Commonwealth Edison
 One First National Plaza, Chicago, Illinois
 Address Reply to: Post Office Box 767
 Chicago, Illinois 60690 - 0757

Subject: Byron Station Units 1 and 2
Application for Amendment to Facility
Operating Licenses NPF-37 and NPF-66,
Appendix A, Technical Specifications
NRC Docket Nos. 50-454 and 50-455

COMMONWEALTH EDISON RESPONSE TO

NRC QUESTIONS REGARDING BORAFLEX

FIGURE 1

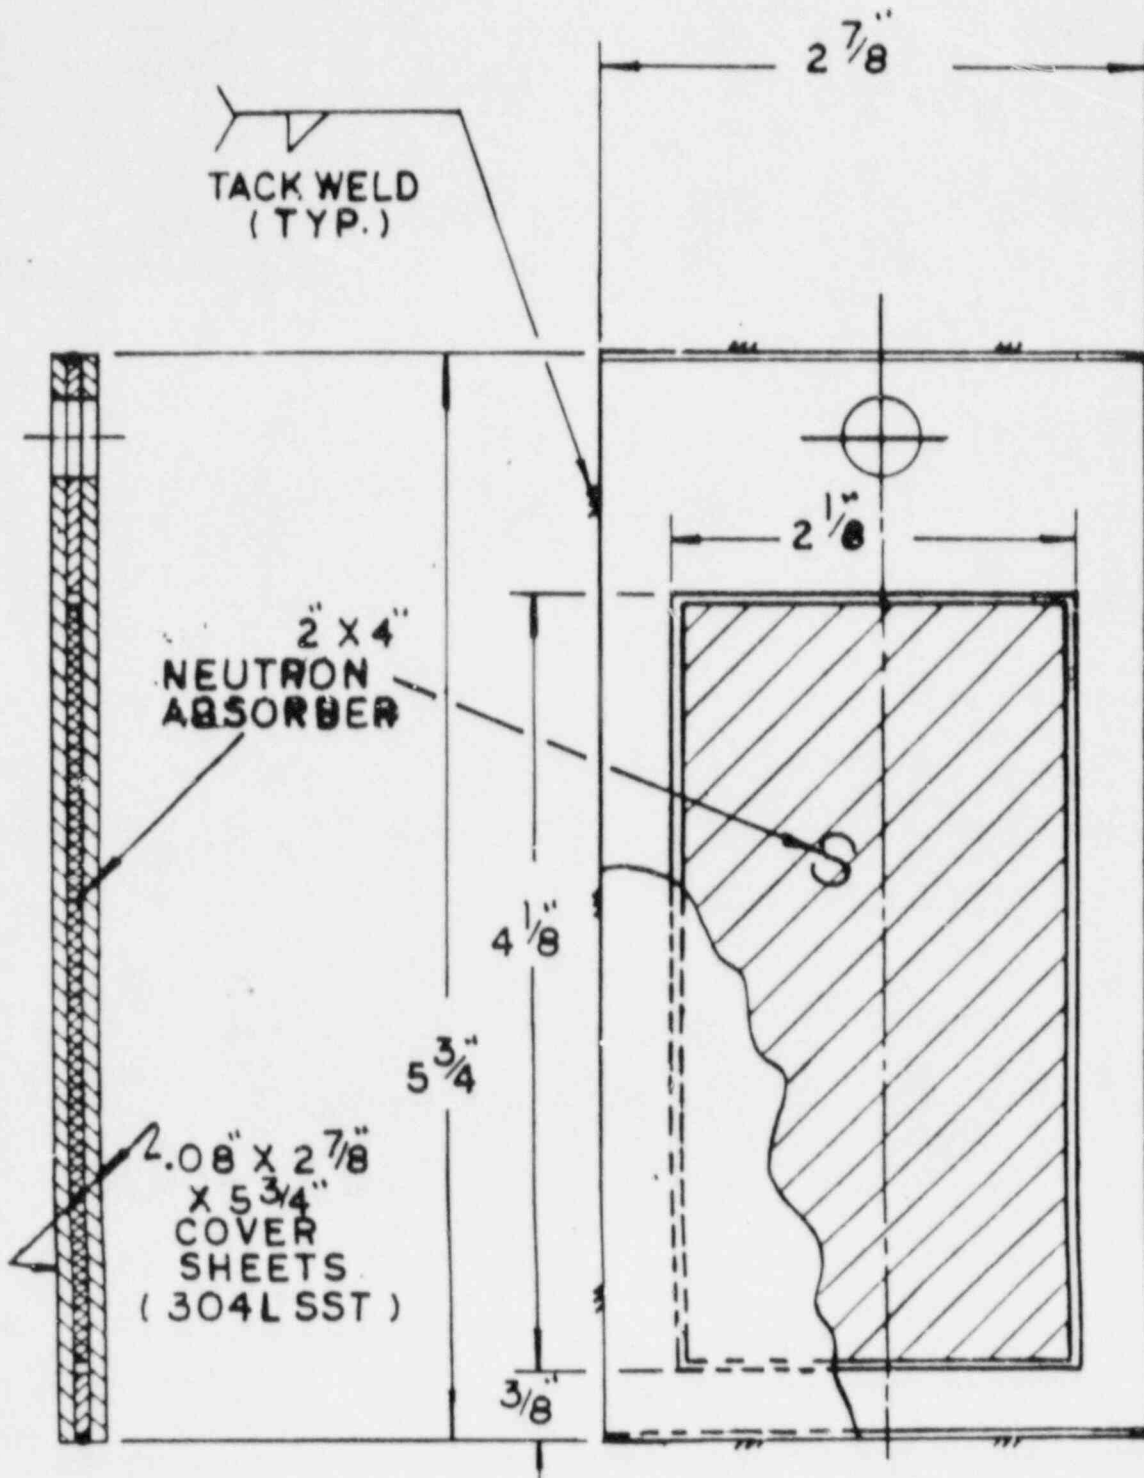
In the case of Byron, twenty test samples per region are to be fabricated in accordance with Figure #1 and installed in the pool prior to storing spent fuel in or near the Region I and the Region II racks.

FIGURE 2
DIMENSIONAL STABILITY MEASUREMENTS

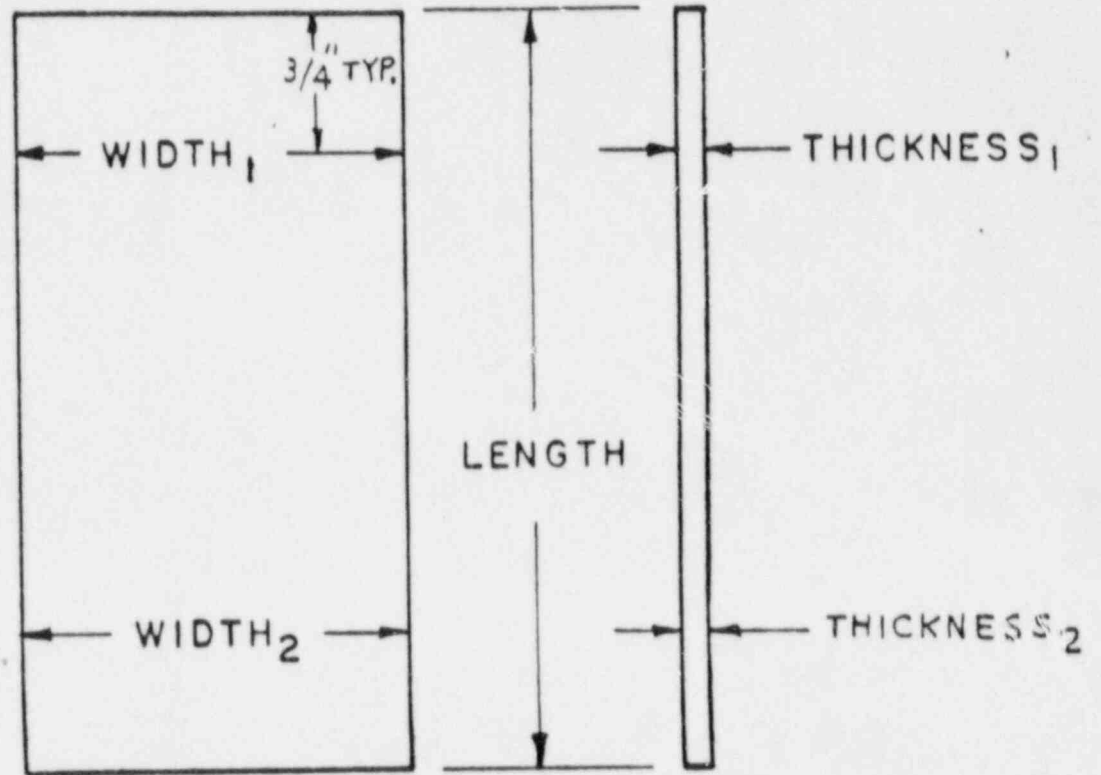
Fig. 2 illustrates the points where width, thickness and overall length are measured. Measurements are performed with a precision micrometer. Table 1 is the data form for dimensions measurements.

Limitations: The dimensional change should not be more than 2-1/2% of the original.
